Improper Connection of Ring Terminals with Heat Shrink Tubing

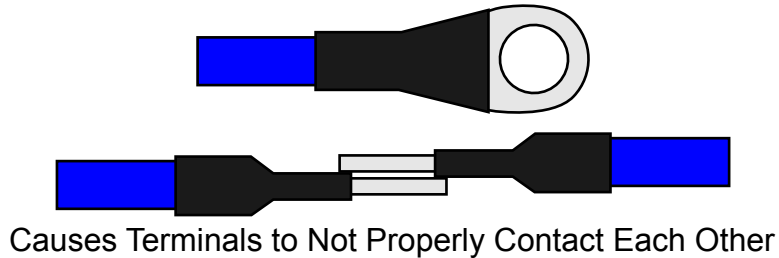
Condition: Ring terminals connected together by a stud do not make proper electrical connection with each other.

Cause: Factory installed heat shrink tubing too close to the hole of a ring terminal.

Correction: Use a sharp blade to cut the heat shrink tubing back to an acceptable distance from the hole in the ring terminal.
